Liquid Stone Concrete - CSP

Site Plan (22-165)

Background:

➤ IH-35 Building Design (a)

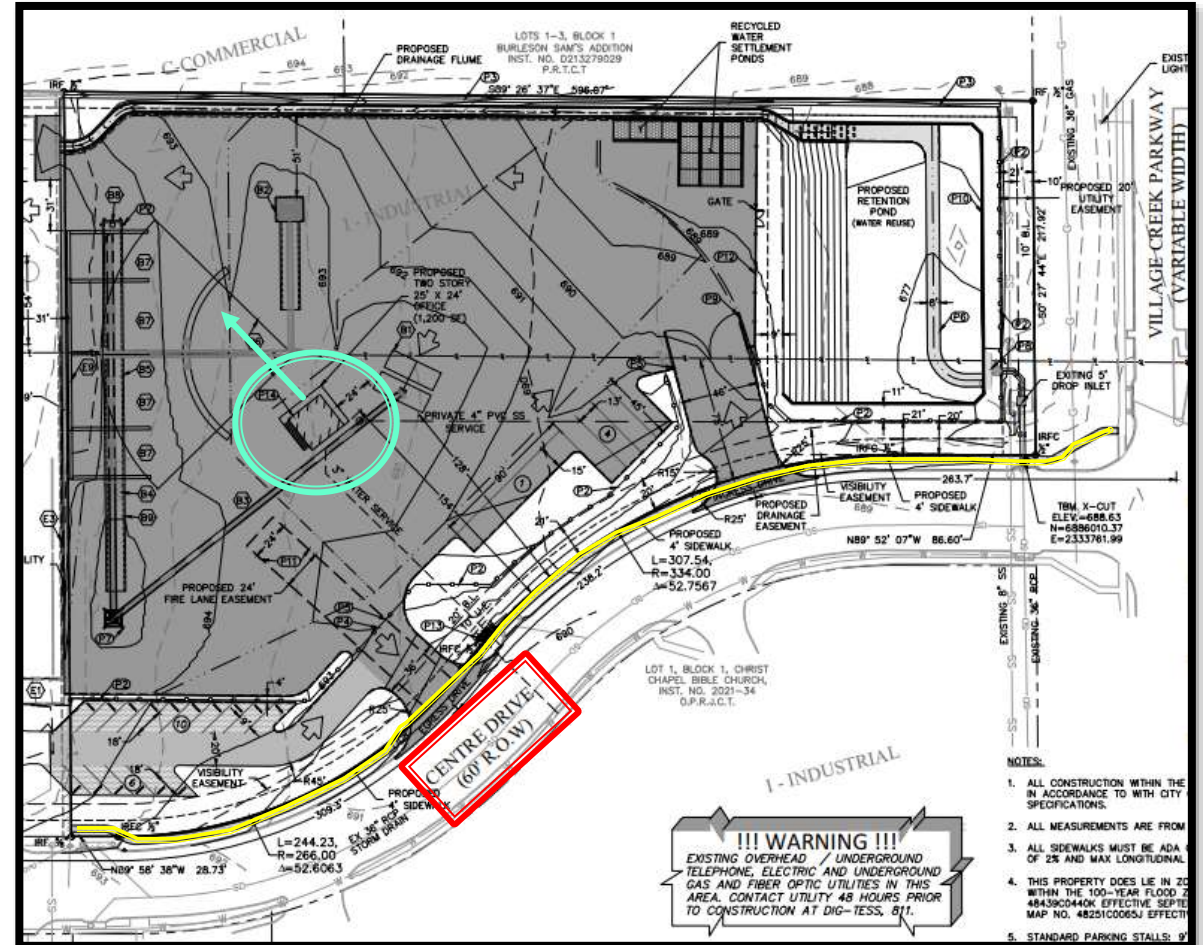
<u>Required:</u>	One primary entryway shall face the principal street and connect directly to a sidewalk along the principal street.
<u>Provided:</u>	Primary entryway will not face towards nor connect to principal street. Sidewalk will be constructed along principal street.
<u>Justification:</u>	Primary use of the site is industrial. The main building / site are not intended for public use and will be screened accordingly

04 SOUTH ELEVATION

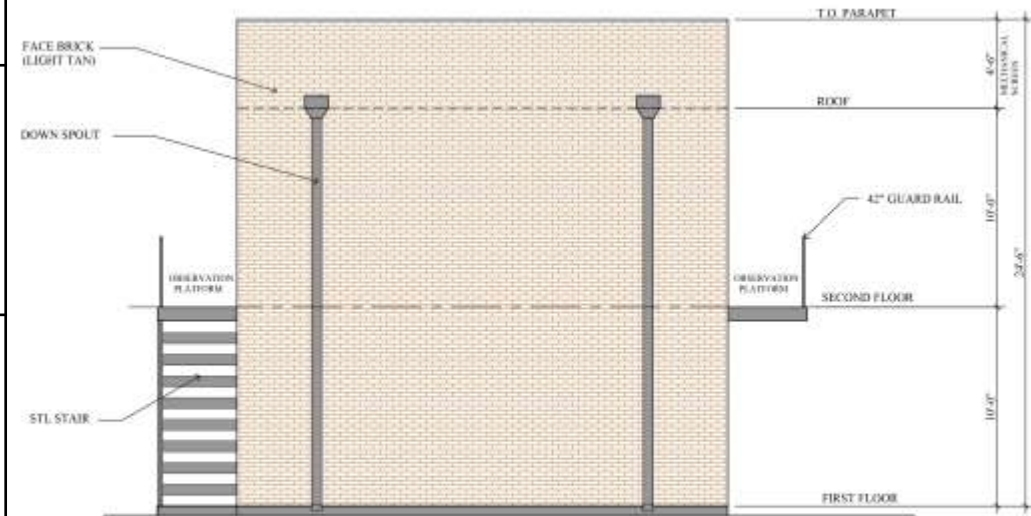
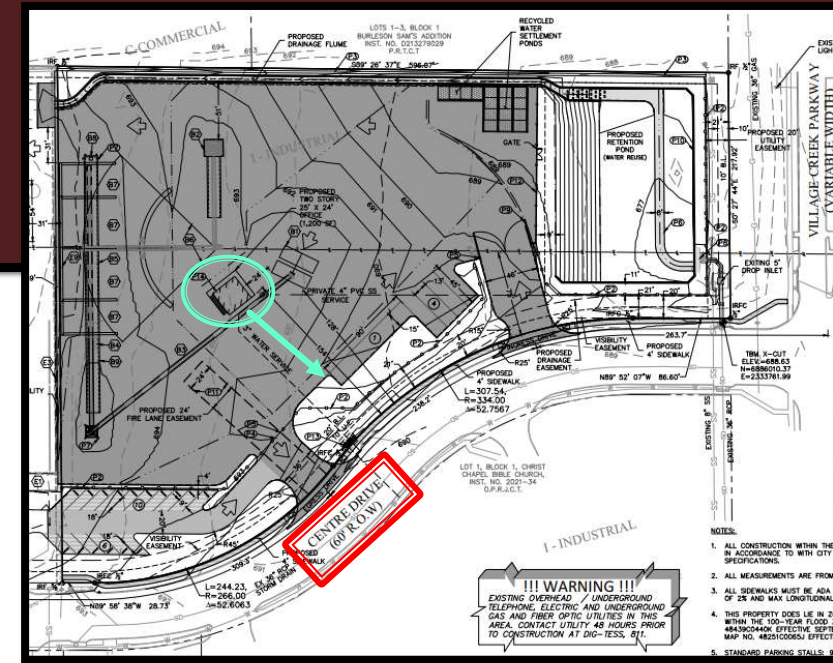
<p><u>Required:</u></p>	<p>On the building façade facing the principal street, at least 35 percent of the wall area on the first floor shall consist of windows or similar glazing</p>
<p><u>Provided:</u></p>	<p>South façade facing the principal street does not provide any glazing.</p> <ul style="list-style-type: none"> • North elevation: 15% • East elevation: 13%
<p><u>Justification:</u></p>	<p>Building is designed as a control area for the plant with specific views to the equipment and trucks. Windows are intended for observation of strategic operations and safety requirements.</p>

100% MASONRY
0% GLAZING

03 EAST ELEVATION
14' x 14'

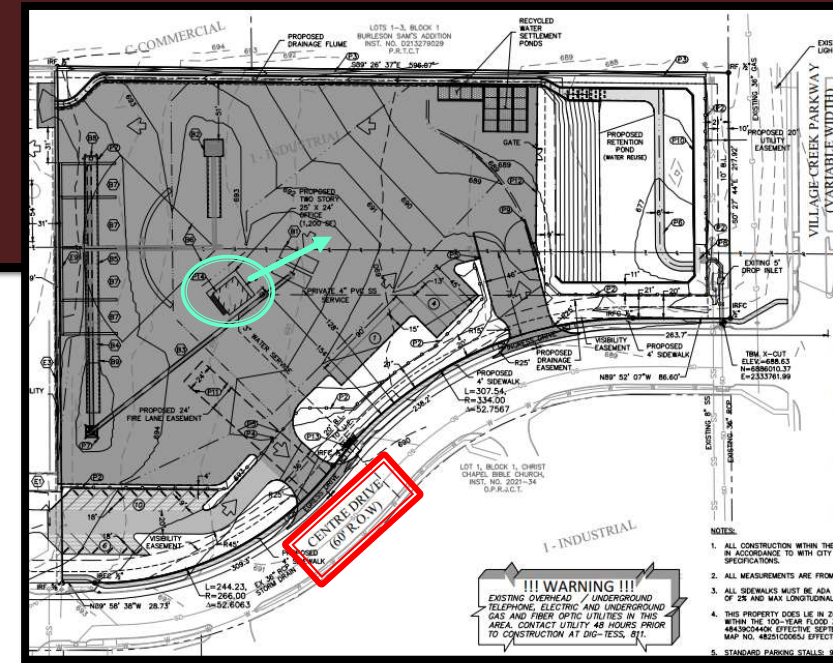
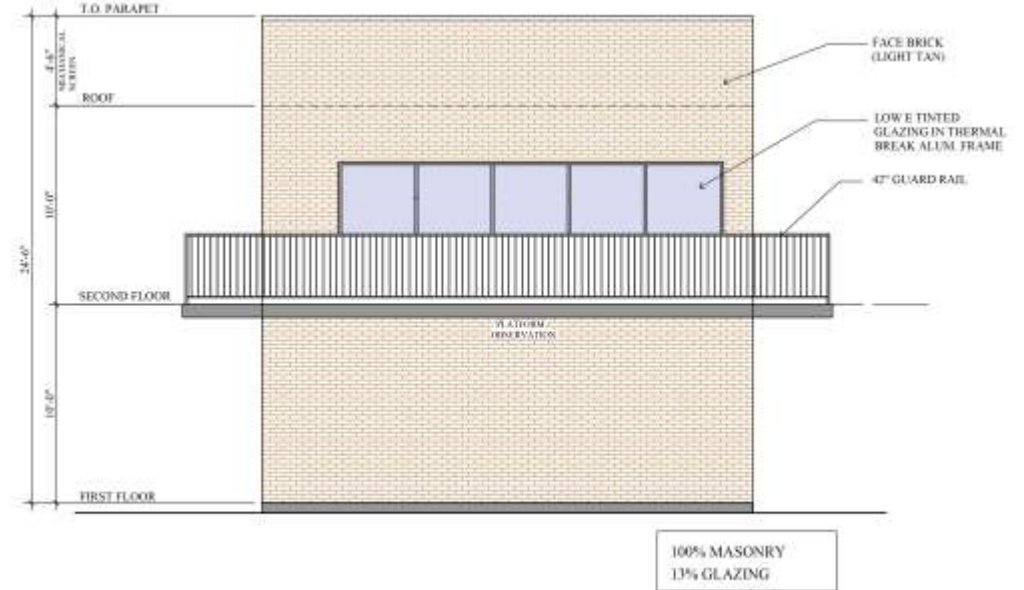
<u>Required:</u>	On all other publicly visible façades, at least 20 percent of the wall area shall consist of windows or similar glazing.
<u>Provided:</u>	Other publically visible façade to the east provides 13% glazing <ul style="list-style-type: none"> • North elevation: 15%
<u>Justification:</u>	Building is designed as a control area for the plant with specific views to the equipment and trucks. Windows are intended for observation of strategic operations and safety requirements.

➤ IH-35 Building Design (g)

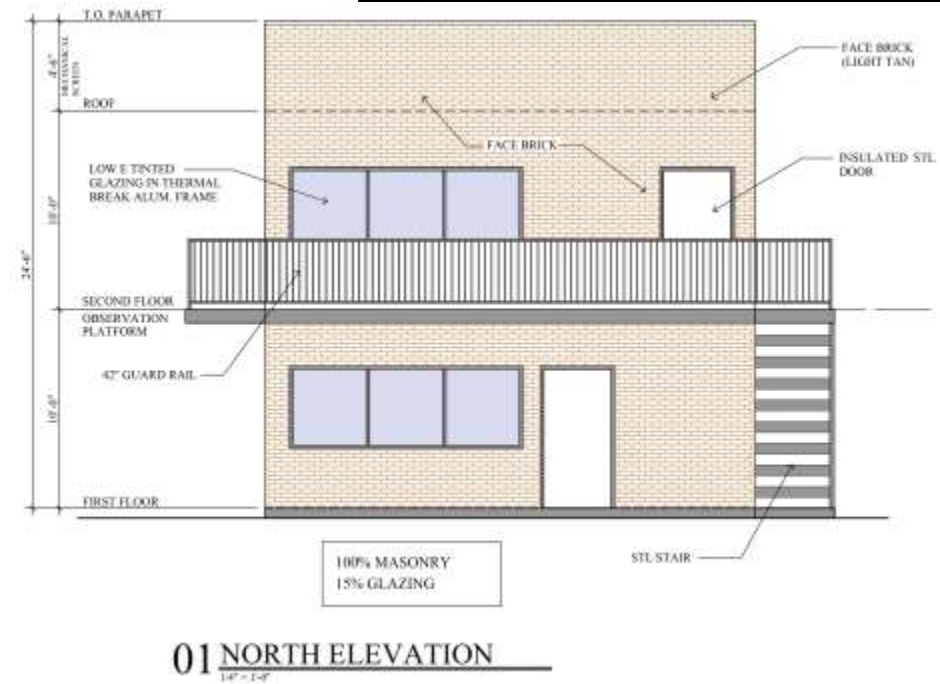
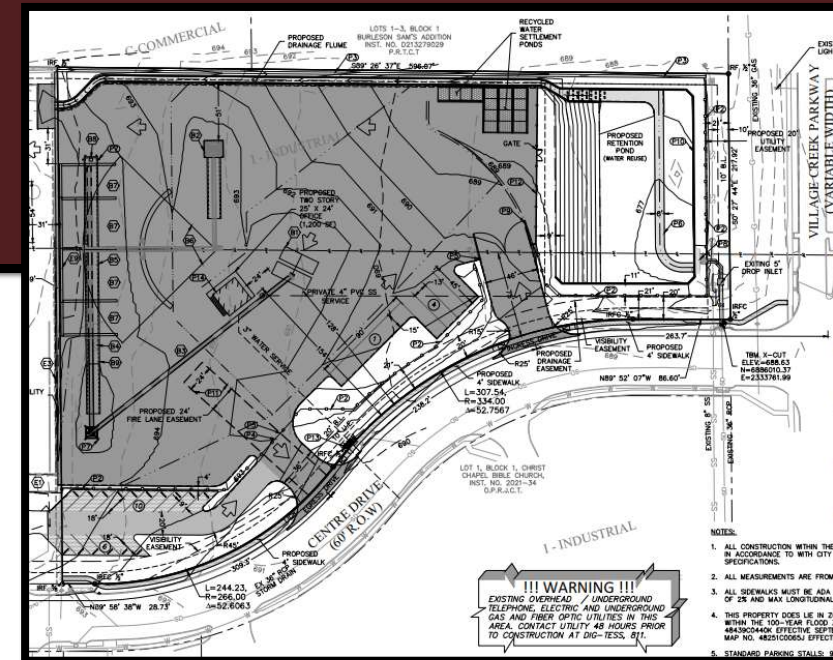
<p><u>Required:</u></p>	<p>Buildings shall provide a minimum of three building design elements as provided in the IH-35 Building Design Section.</p>
<p><u>Provided:</u></p>	<p>None of the building design element options are being applied to the proposed building.</p>
<p><u>Justification:</u></p>	<p>The design standards are intended to be for a safe and secure industrial facility. The building/site is not intended for public use, therefore no additional building designs or architectural elements are being installed.</p>

➤ IH-35 Landscaping (h)

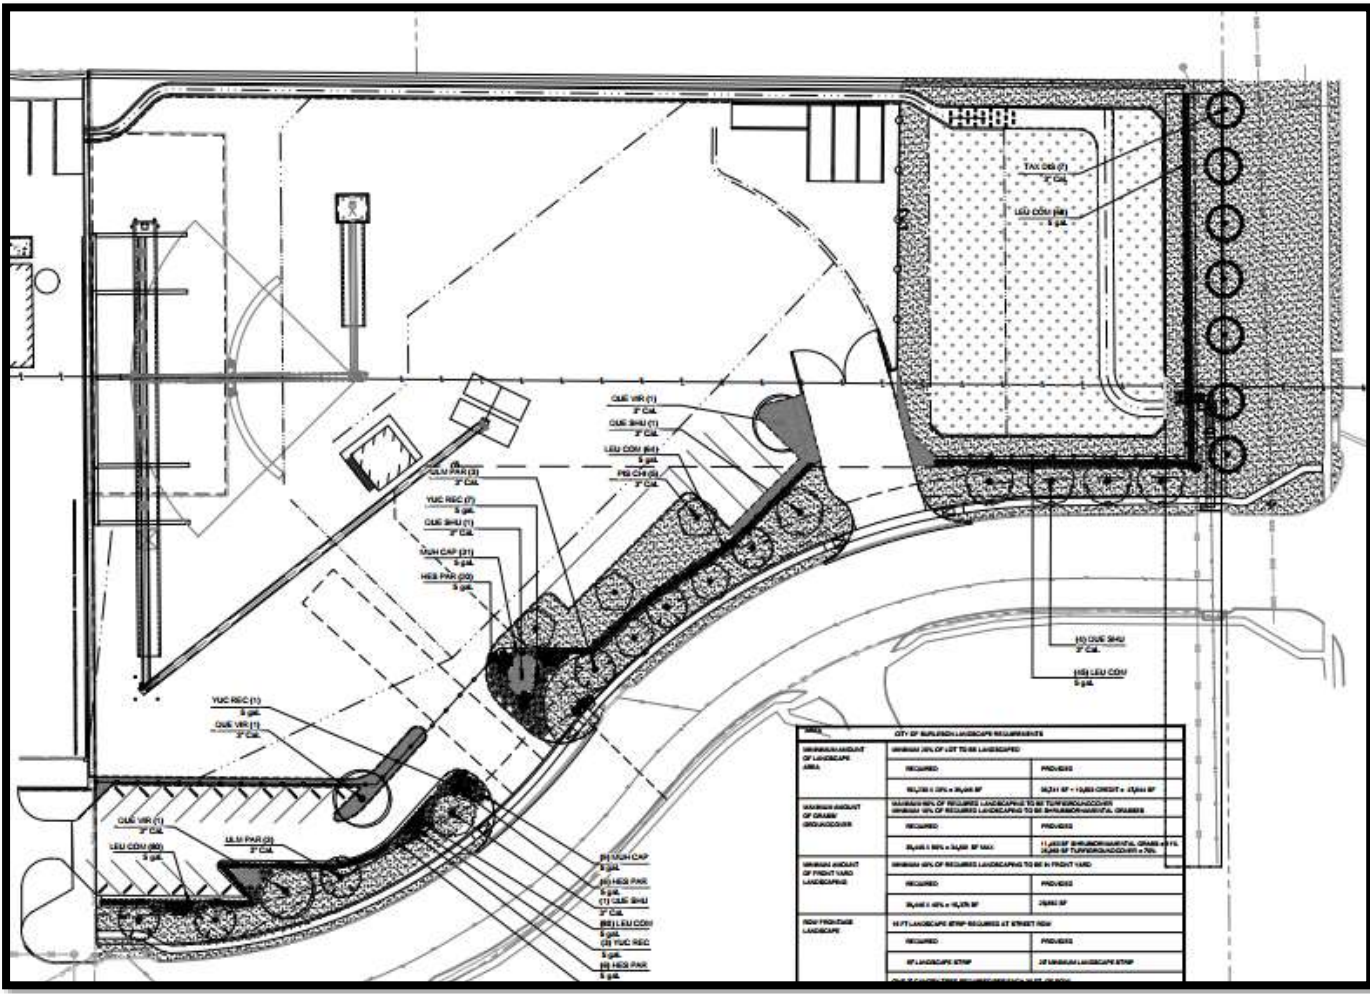
<u>Required:</u>	Developments shall provide at least 25 percent of the required landscaping area as natural open
<u>Provided:</u>	Proposing to provide 14.3% open space in lieu of the required 25%.
<u>Justification:</u>	Due to detention requirements, equipment circulation and safety, the public open space cannot be satisfied entirely.

➤ IH-35 Screening (a)

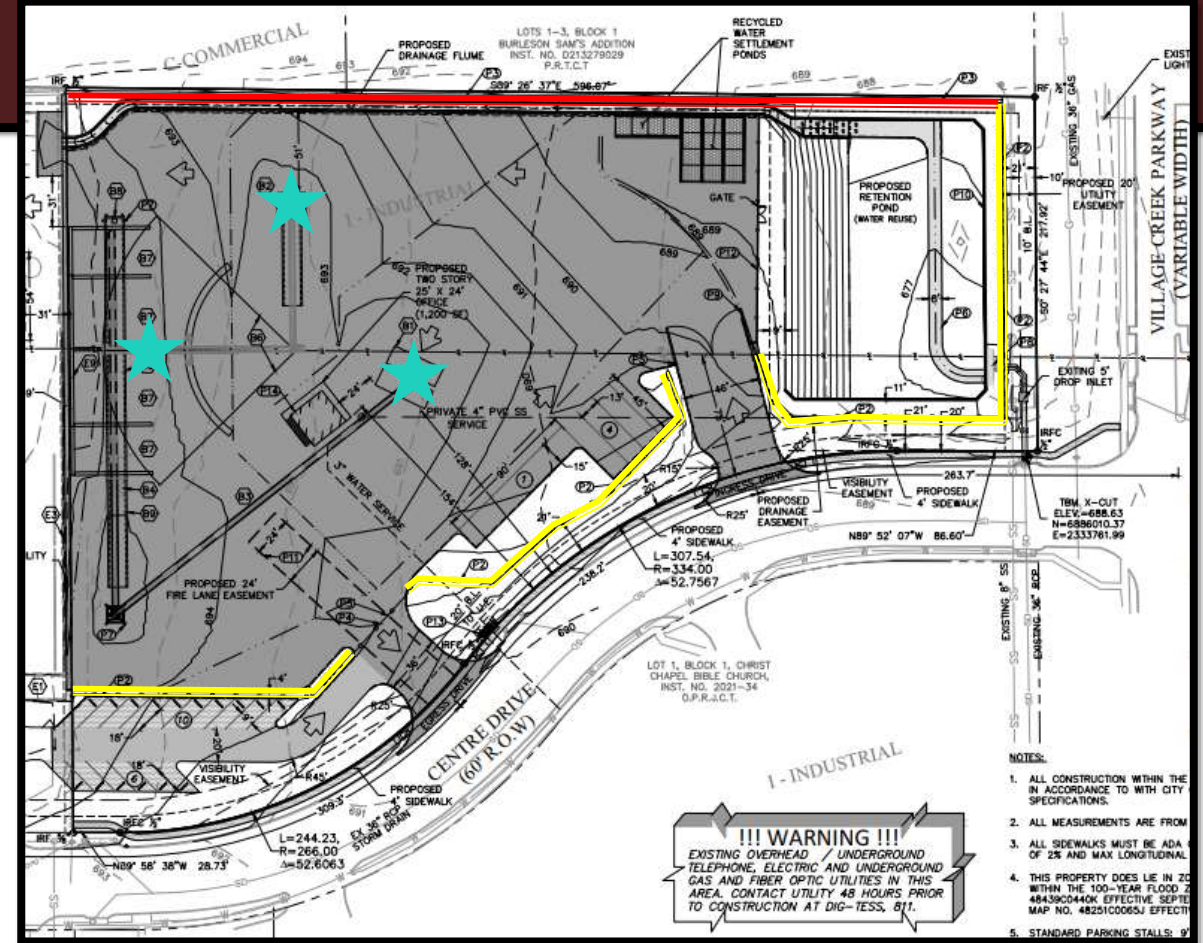
<p><u>Required:</u></p>	<p>Mechanical equipment and other support elements for buildings shall be screened from view of any person standing on the property line.</p>
<p><u>Provided:</u></p>	<ul style="list-style-type: none"> • 8' masonry wall along the south and east (principal) sides of the property • 12' masonry wall along the north (rear) property boundary.
<p><u>Justification:</u></p>	<p>Screening the equipment entirely cannot be achieved due to the height of batching equipment = 42 – 85 feet</p>

Per the Texas Commission on Environmental Quality (TCEQ):

- 12 foot screening wall; or
- 50 foot buffer from all equipment shall be provided.

The northern property line is the only property line that does not meet the 50' buffer requirement so a 12' masonry fence was proposed.
